# Technical Service Information

## **FORD 5R44E/5R55E INTERMEDIATE SHAFT SENSOR ADDED AND NEW TRANSMISSION FOR 2001**

## NEW CASE AND SPEED SENSOR

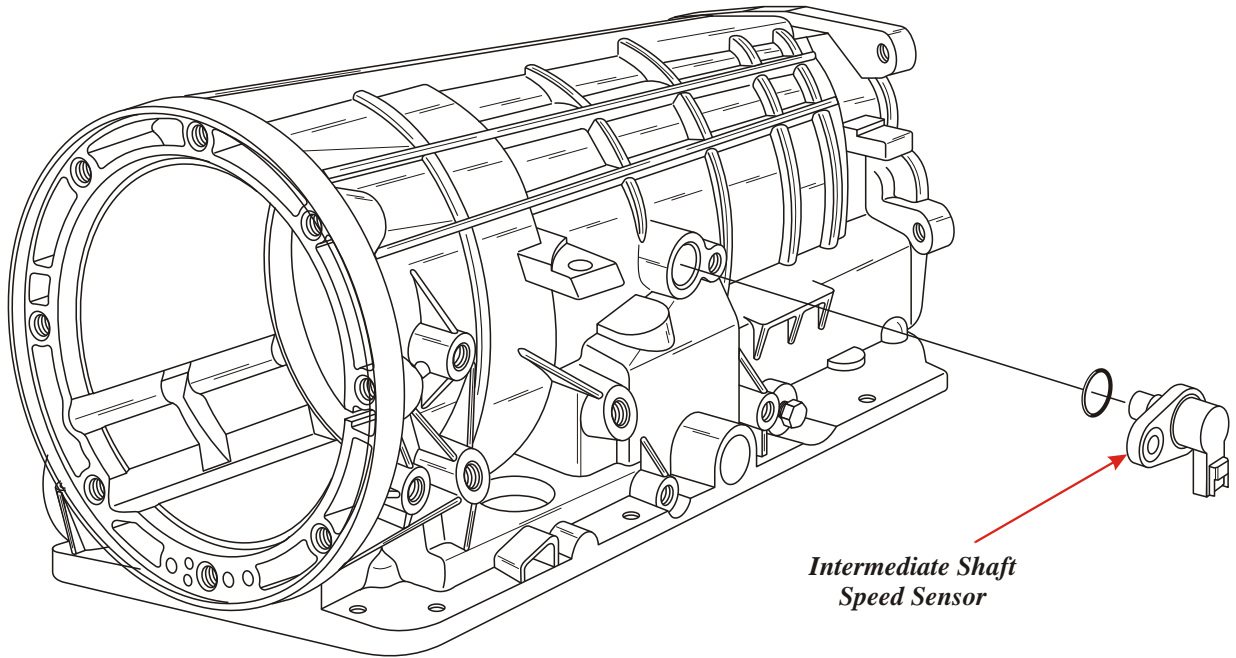
- (1) TRANSMISSION CASE - New transmission case casting and machining to accommodate the added Intermediate Shaft Sensor (ISS), as shown in Figure 1.
- (2) INTERMEDIATE SHAFT SPEED SENSOR - Additional information for the PCM to determine various incremental pressure changes needed to minimize the difference between the actual and ideal shift times for Shift Adaptive Pressure Control Strategy.
- (3) SUN SHELL - Now manufactured with windows and used to trigger the added Intermediate Shaft Speed (ISS) sensor, as shown in Figure 2.
- (4) POWERTRAIN CONTROL MODULE - Operational changes that includes Shift Adaptive Electronic Pressure Control Strategy.

Figure 2

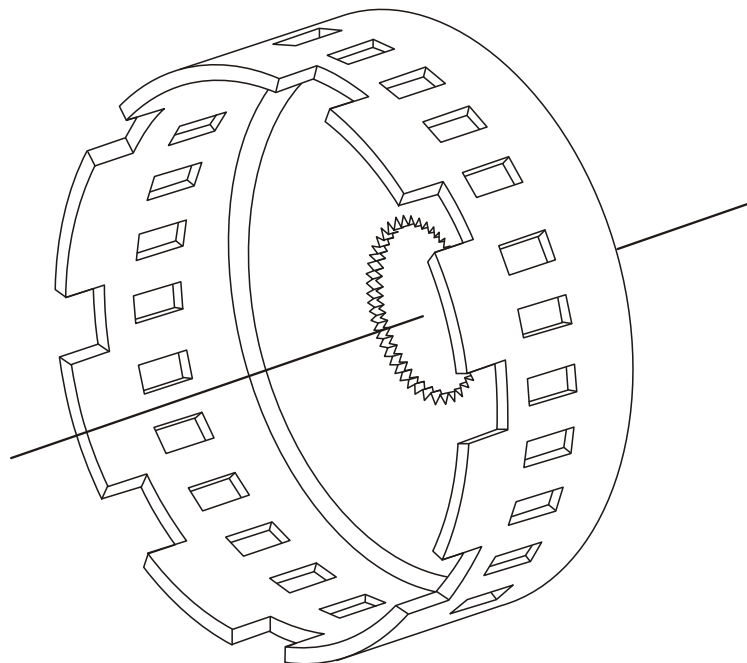
## NEW SUN GEAR SHELL

Figure 3

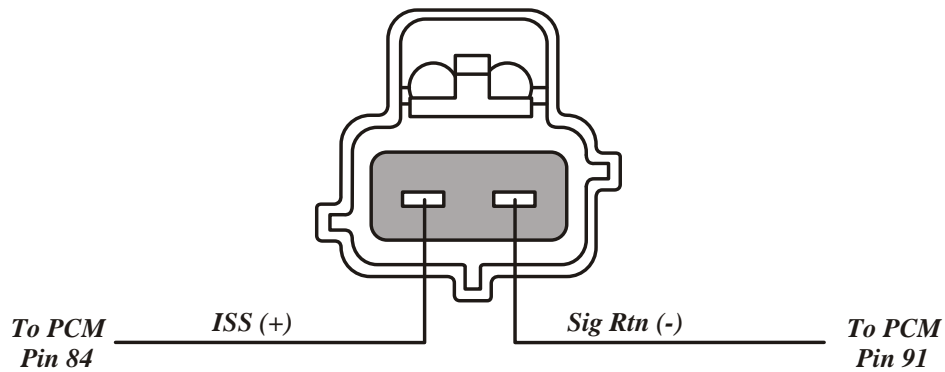
## 5R44E/5R55E ADDED DIAGNOSTICS AND TROUBLE CODE CHART

DTC	DESCRIPTION	SYMPTOM	POSSIBLE CAUSES
P0791	ISS Sensor Failure (Signal Loss)	Harsh 2-3 Shifts	ISS Sensor or Wiring
P0794	ISS Sensor Signal Intermittent	Harsh 2-3 Shifts	ISS Sensor or Wiring
P1636	SSx ISIG Communication Error	None	Replace PCM

*Intermediate Shaft Speed Sensor  
325-485 Ohms Resistance @ 20°C (70°F)*
